Tuerk House - Phase-4 RM Sovich Architecture

Item #	RFI#	Name	Date received	Generated by	Dwg / Spec #	Description/question	Conflicting Sheet/ Spec #	Date/ Forwarded to	Date/ Received from	Arch/Engineer Response Date	Arch/ Engineer Response Date	Arch / Engineer Response	Revised drawings/Spec.	Responsibility	Status	ADDENDUM #
1	1	Kim	8/25/23	TBI		Please provide more details on the steps from the penthouse to the roof.						Stair is a non penetrating stair system. Attachment detail if required will be provided once shop drawings are submitted. Refer to specification sheet on section 055000 - non penetrating roof top stair system.		Architect	New Item	ADD#01
2	1	Kim	8/25/23	TBI		2. There is no roof spec. Please provide more detail regarding both roofs.						For the shade roof refer to specification on section 074000. For the canopy roof see the attached spec section 07 53 23 ADHERED EPDM ROOF.		Architect	New Item	ADD#01
3	1	Kim	8/25/23	TBI		3. There are metal guardrails @ Ashburton St main entrance det D6/A2.01, and at stepped seating det B6/A2.5. both are called to be painted. However, ASI-07/5.A calls for stainless steel. Please advise if any railing needs to be field painted.						P

S1.05
 TRELLIS STRUCTURAL PLANS, SECTIONS AND DETAILS

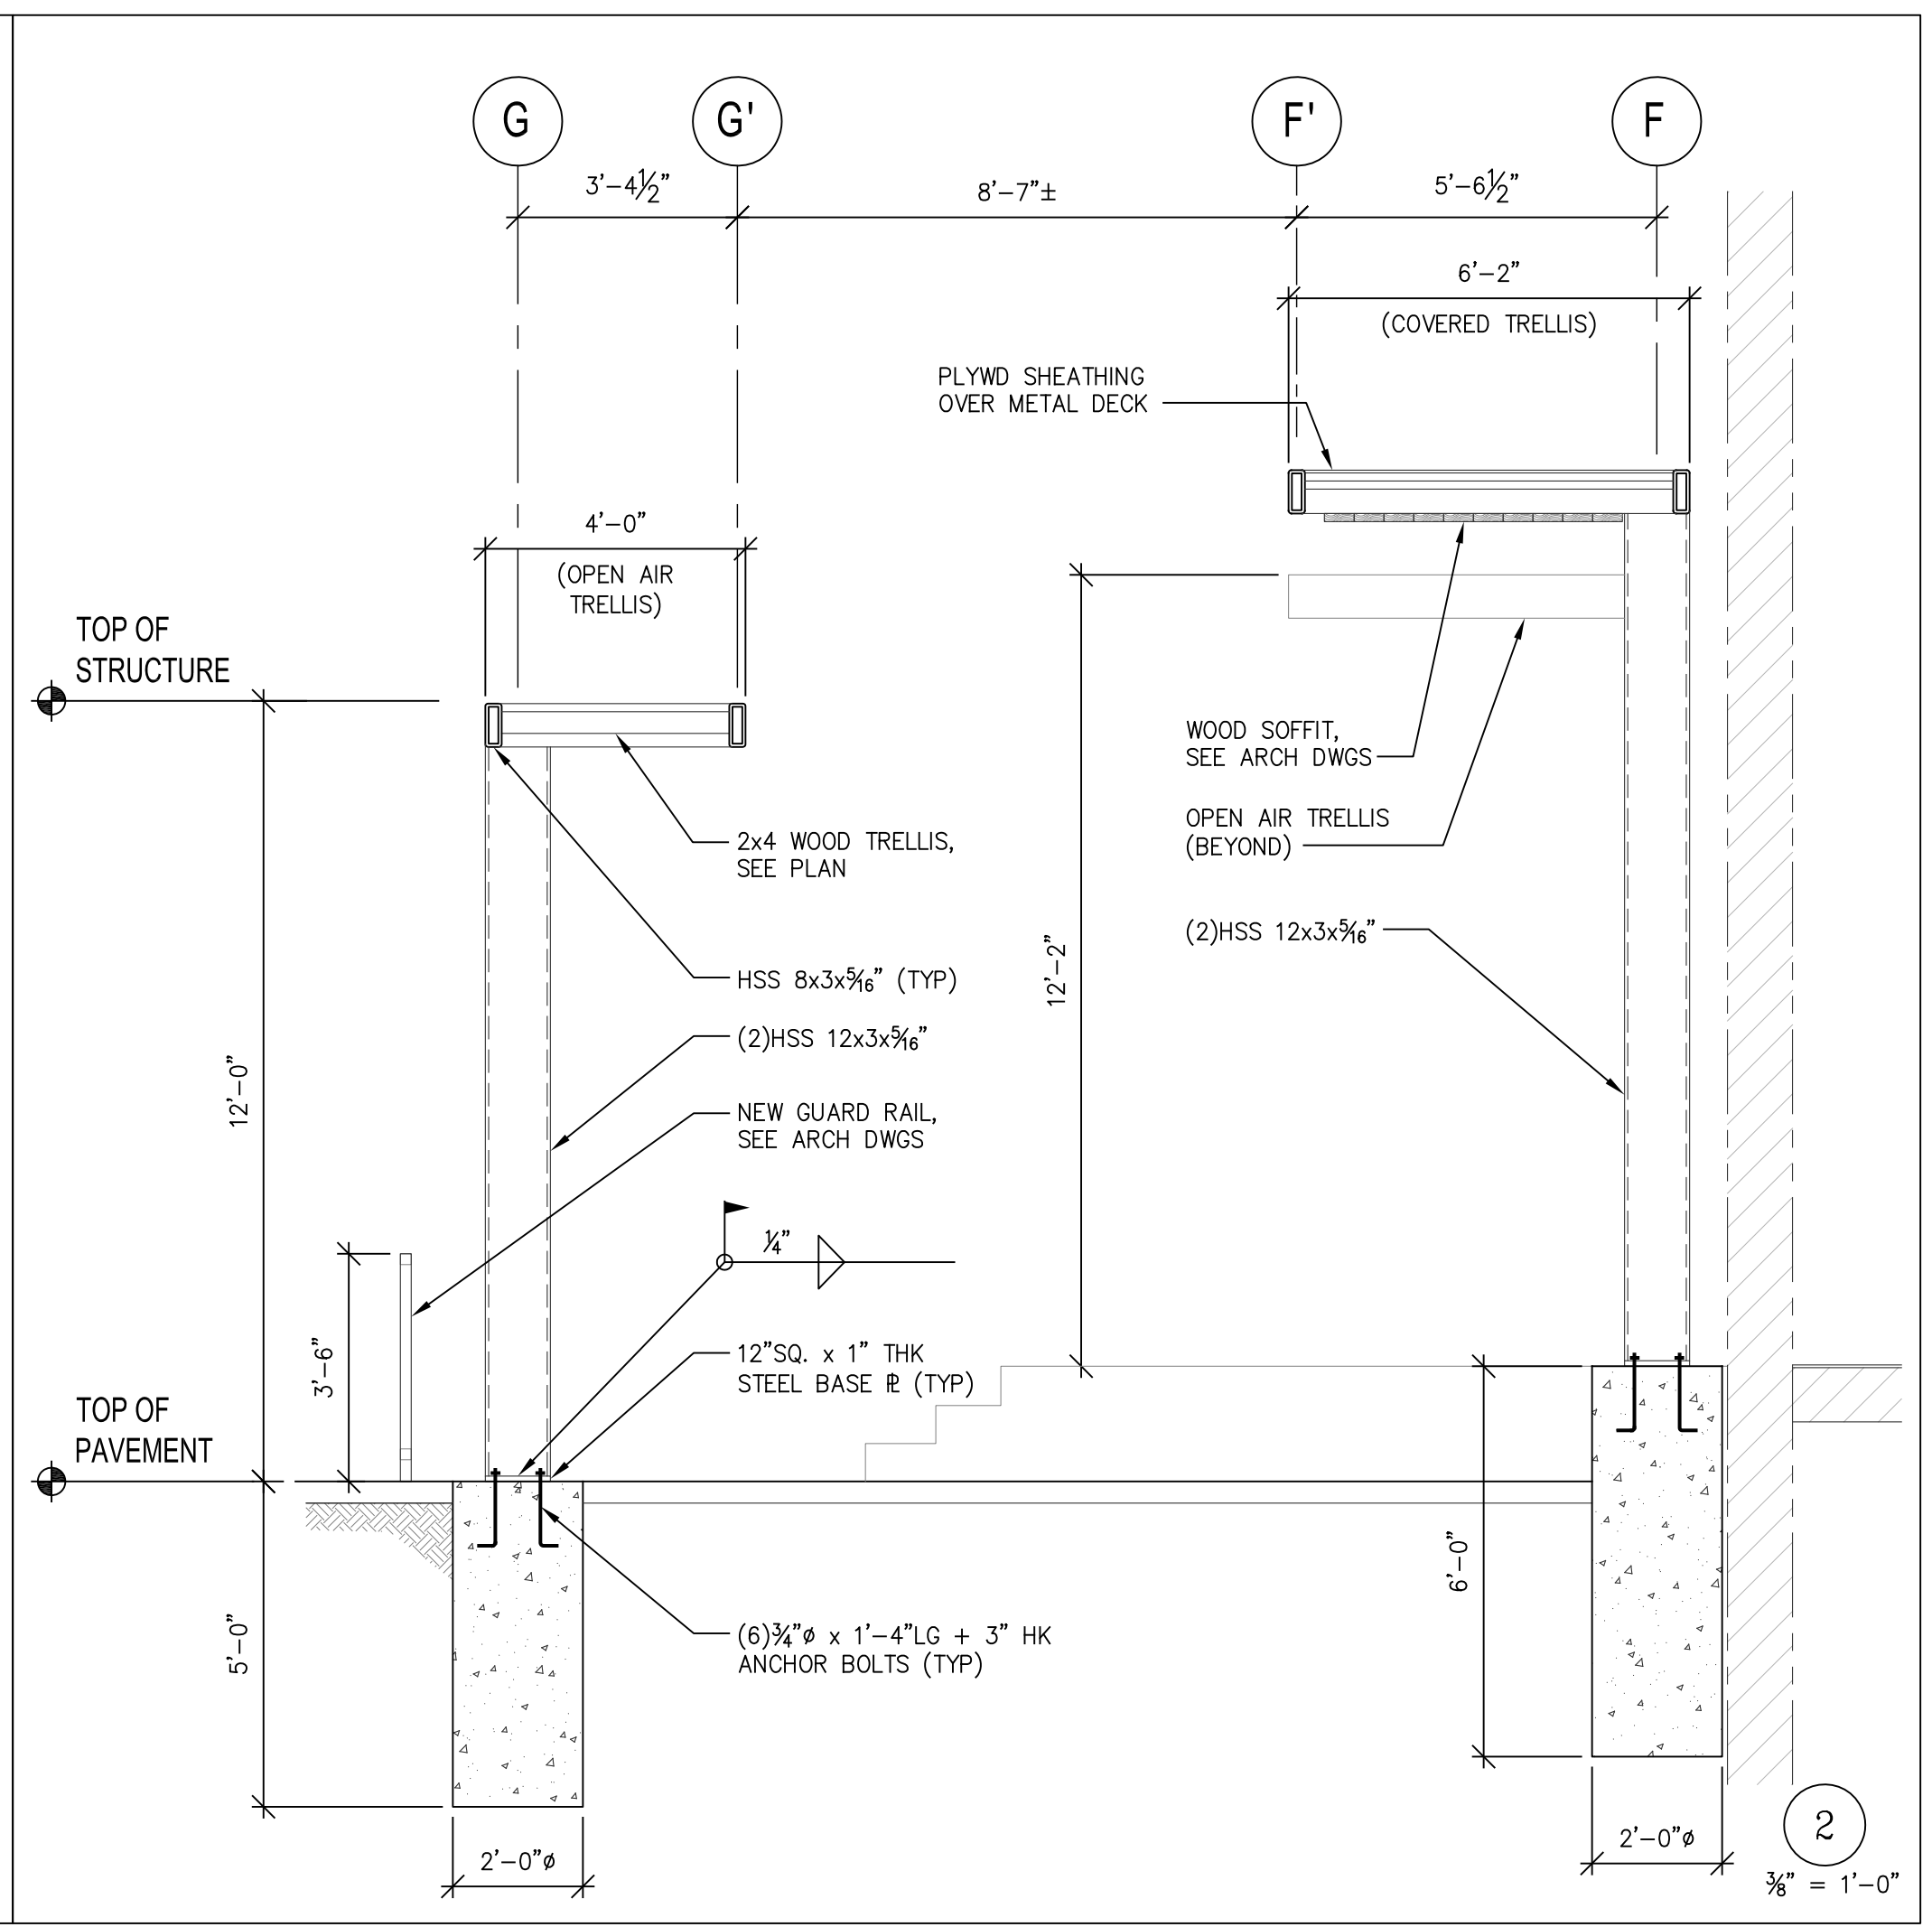
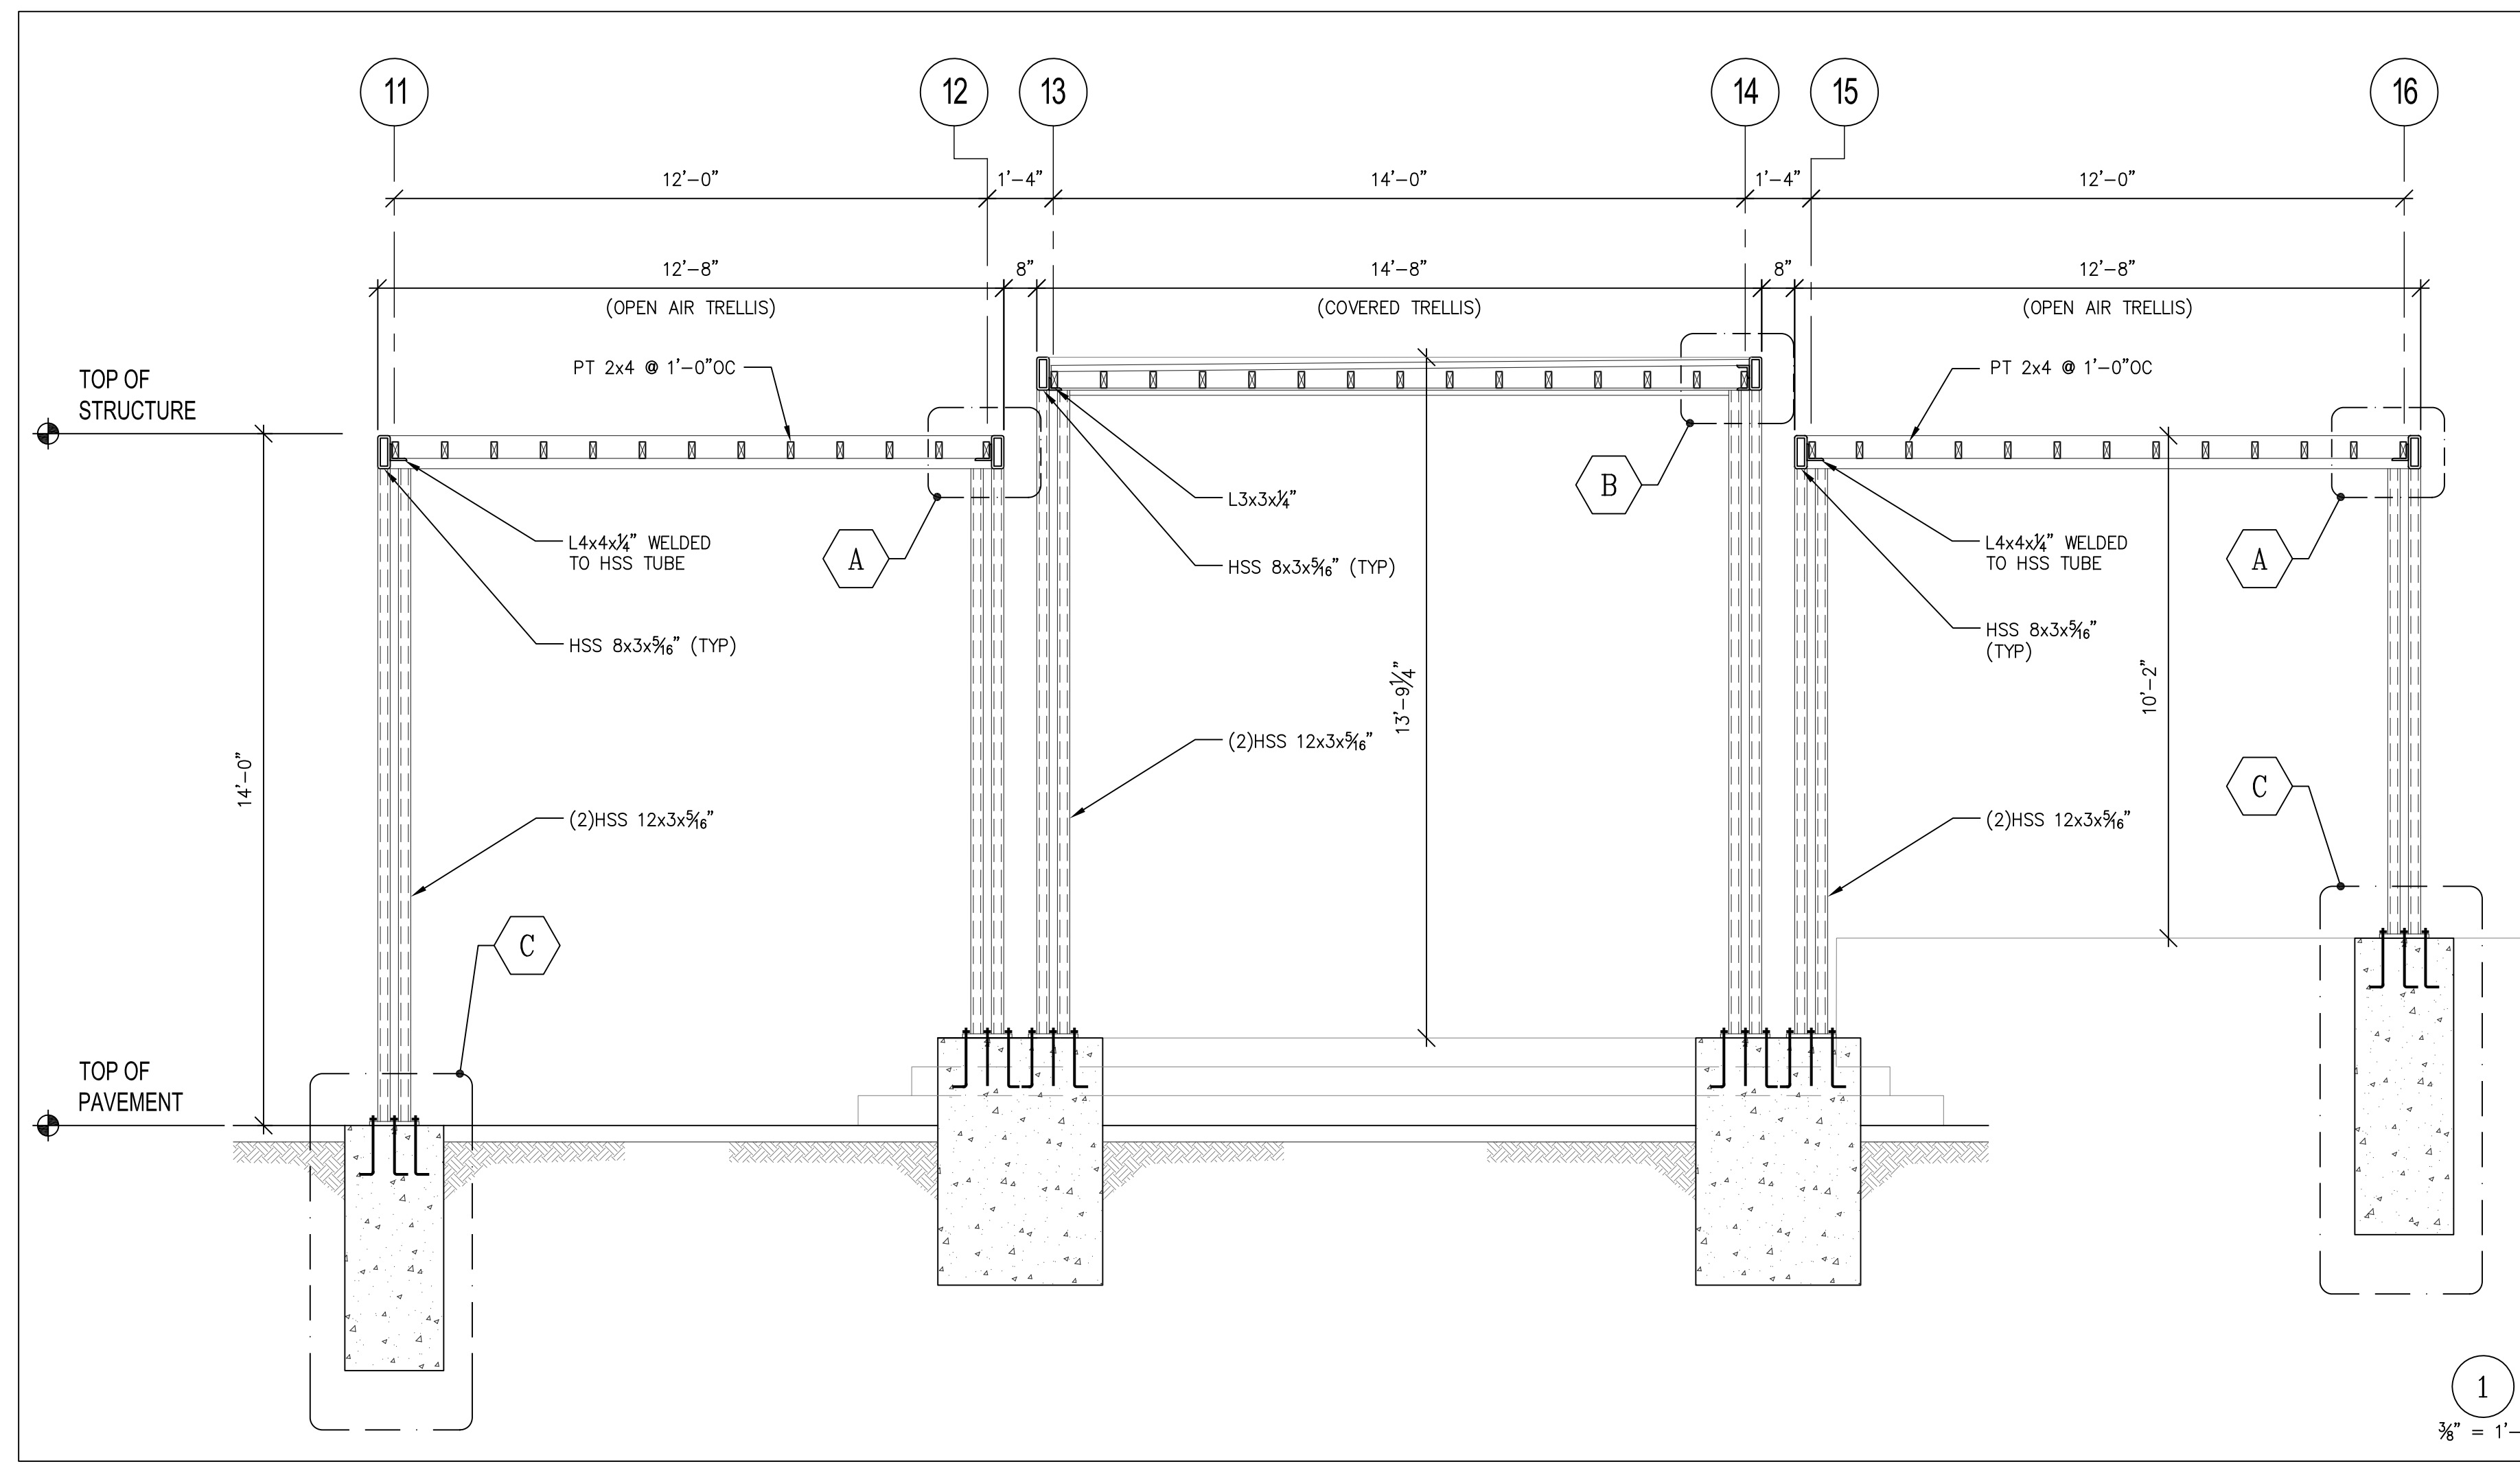
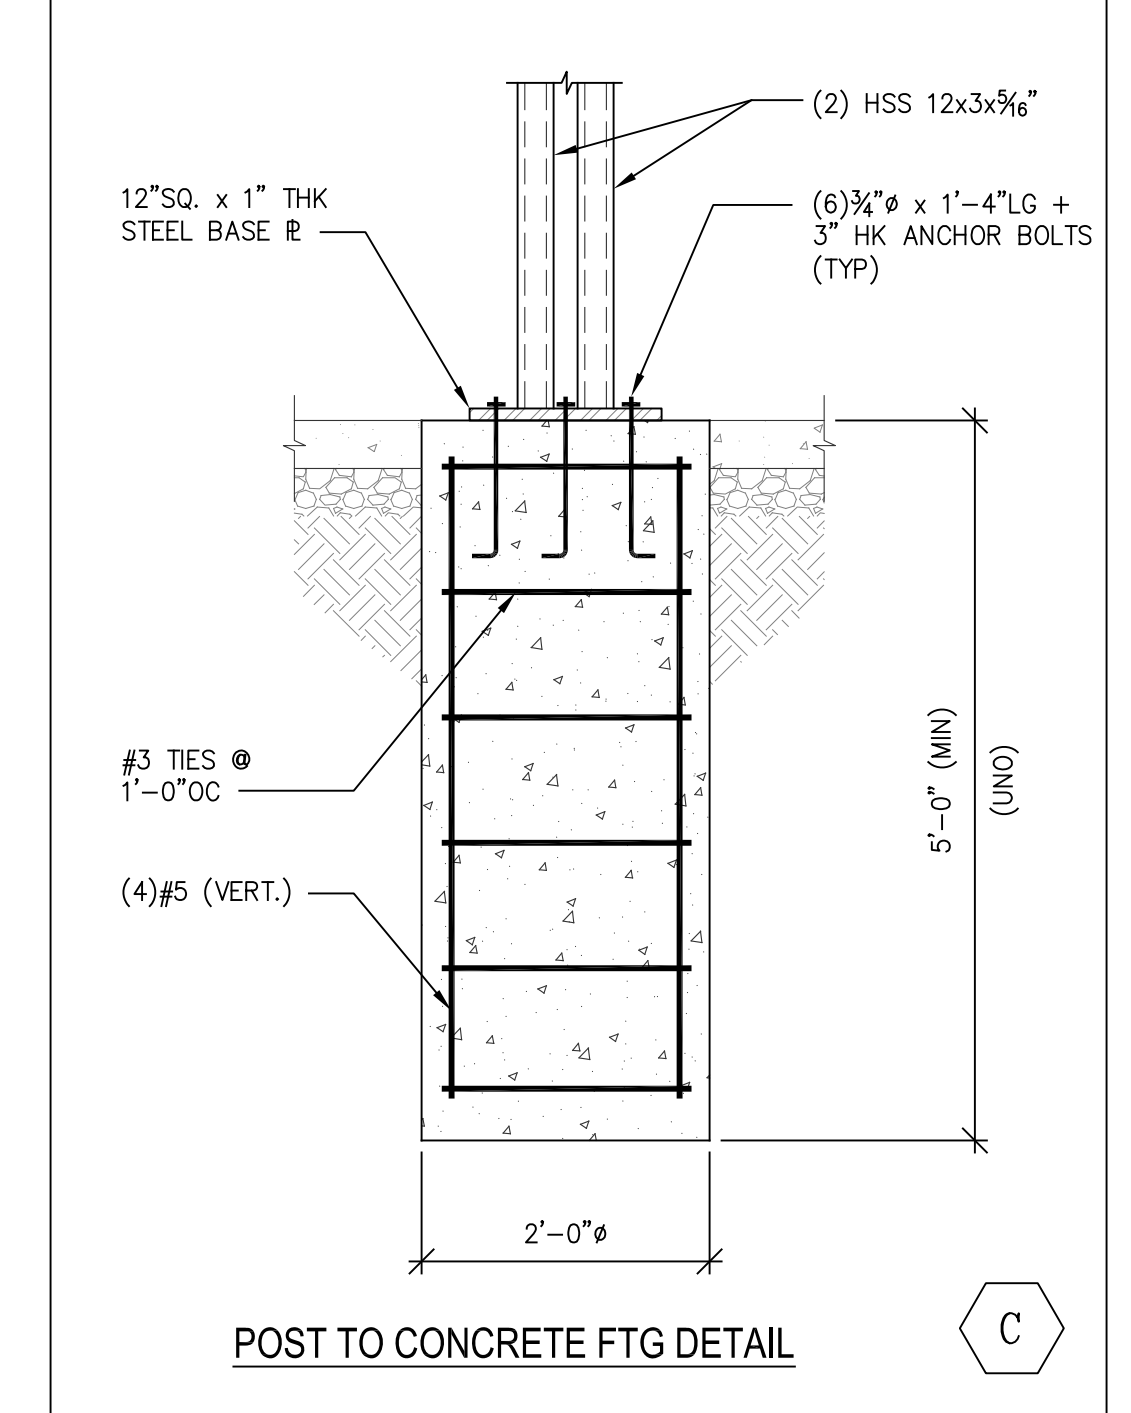
4	1	Kim	8/25/23	TBI		4. Trellis structures, at front & side entrances and rear yard call for clear satin finish on cedar. Please advise what type of finish is to be provided.						Provide clear satin finish.		Architect	New Item	ADD#01
5	1	Kim	8/25/23	TBI		5. The trellis on the front of the building, A2.03 shows the columns and some framing out of steel. I don't see any more detail on the structural drawings about this trellis though as far as steel sizes and elevations. Please advise.		8/25/23 SKA				See the attached Structural drawing S1.05.	S1.05	Structural	New Item	ADD#01
6	1	Kim	8/25/23	TBI		6. Is western red cedar fine for the trellis infill?						Yes.		Architect	New Item	ADD#01
7	1	Kim	8/25/23	TBI		7. I am looking at A2.04 to get an idea of the lengths needed for trellis. B3, far left, looks to be like 5'-3" 2x4's. When I go to section B6 & D2, these same 2x4's appears to be 5'-11". Which drawing is correct. Pictured attached below. Section B6 & D2 show this same trellis below the trellis to the left.						The governing dimension is 12'-6 between centerline of column. The length of 2x4 horizontal frame should be about 12'-1/2". See the attached sketch.	SK-280830-01	Architect	New Item	ADD#01
